ABOUT ADSP-BF542/BF544/BF547/BF548/BF549 SILICON ANOMALIES

These anomalies represent the currently known differences between revisions of the Blackfin® ADSP-BF542/BF544/BF547/BF548/BF549 product(s) and the functionality specified in the ADSP-BF542/BF544/BF547/BF548/BF549 data sheet(s) and the Hardware Reference book(s).

NR0034030

25. 05000457 - Host DMA Port Responds to Certain Bus Activity Without $\overline{\text{HOST_CE}}$ Assertion:**DESCRIPTION:**

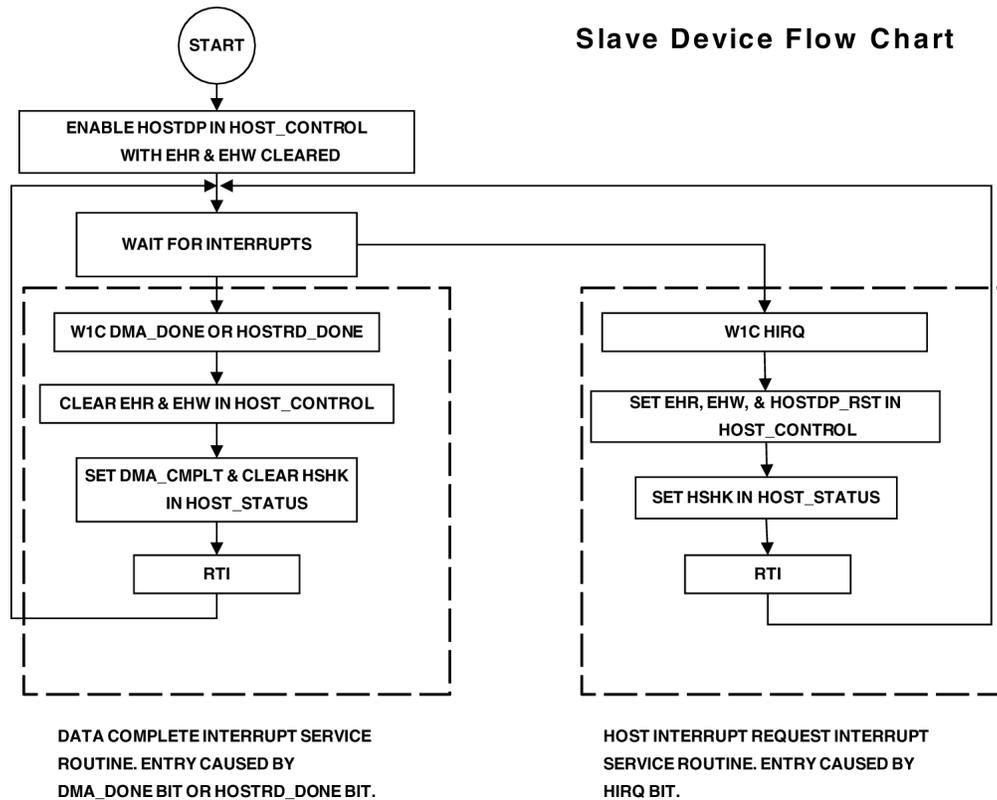
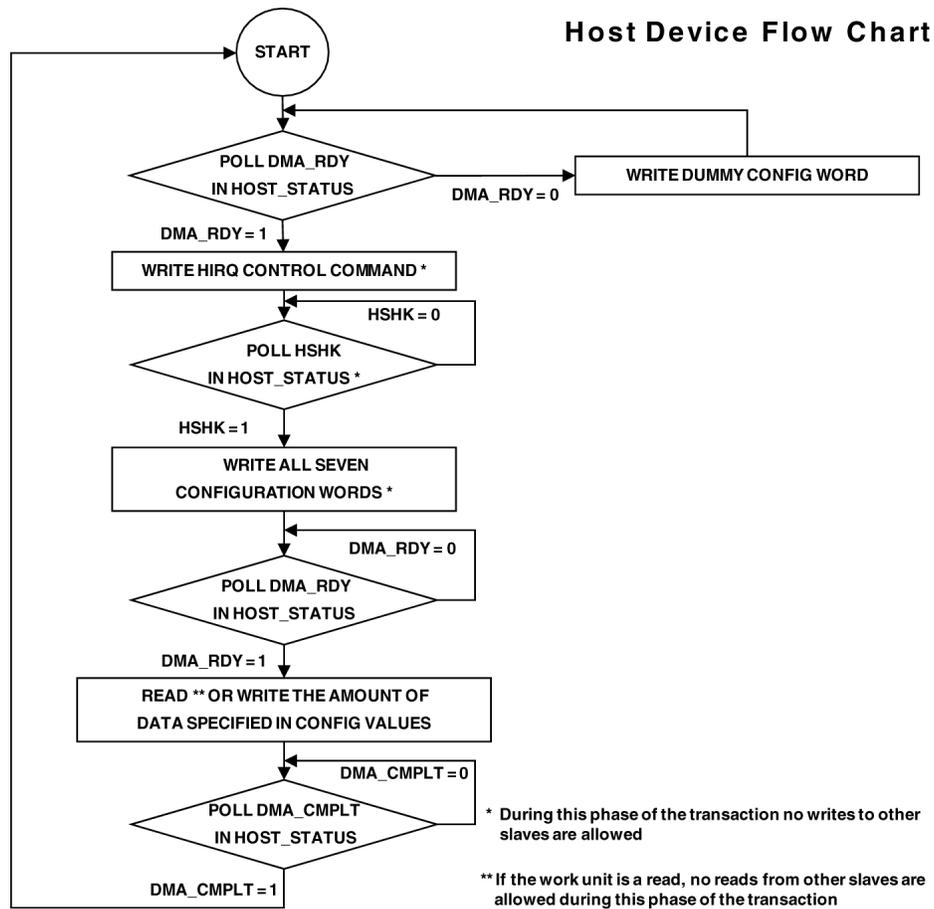
The Host DMA Port (HOSTDP) responds to certain bus activity even without the assertion of its chip enable, $\overline{\text{HOST_CE}}$. If the HOSTDP is the only slave on the bus (meaning that $\overline{\text{HOST_WR}}$ and $\overline{\text{HOST_RD}}$ are asserted by the host only for communicating with the HOSTDP), this anomaly will not be observed. There are two states in which the HOSTDP responds to bus activity (assertion of $\overline{\text{HOST_WR}}$ or $\overline{\text{HOST_RD}}$) without $\overline{\text{HOST_CE}}$ being asserted:

- 1) HOSTDP is Enabled and Waiting for the Host to Configure - While waiting for configuration in both acknowledge and interrupt modes, assertions of $\overline{\text{HOST_WR}}$ for other slaves can cause the HOSTDP to be erroneously configured.
- 2) HOSTDP is Configured for Data Reads - While waiting for data reads in both acknowledge and interrupt modes, assertions of $\overline{\text{HOST_RD}}$ for other slaves can cause the HOSTDP to subsequently return data out of order.

- 1) Add additional logic - Connect to $\overline{\text{HOST_WR}}$ through a 2-input OR gate where one input of the OR gate is the host's write signal and the other is the host's chip select.
- 2) Time bus accesses by the host processor - Do not write to other slaves on the bus between the time that the HOSTDP is enabled and the DMA_RDY bit in HOST_STATUS is set.
- 3) Change the software on both the host and the slave as shown in the following flowcharts:

- 1) Add additional logic - Connect to $\overline{\text{HOST_RD}}$ through a 2-input OR gate where one input of the OR gate is the host's read signal and the other is the host's chip select.
- 2) Time bus accesses by the host processor - Do not read from other slaves on the bus between the time that the final configuration word (YMODIFY) is written to the HOSTDP and the DMA_CMLPT bit in HOST_STATUS is set.
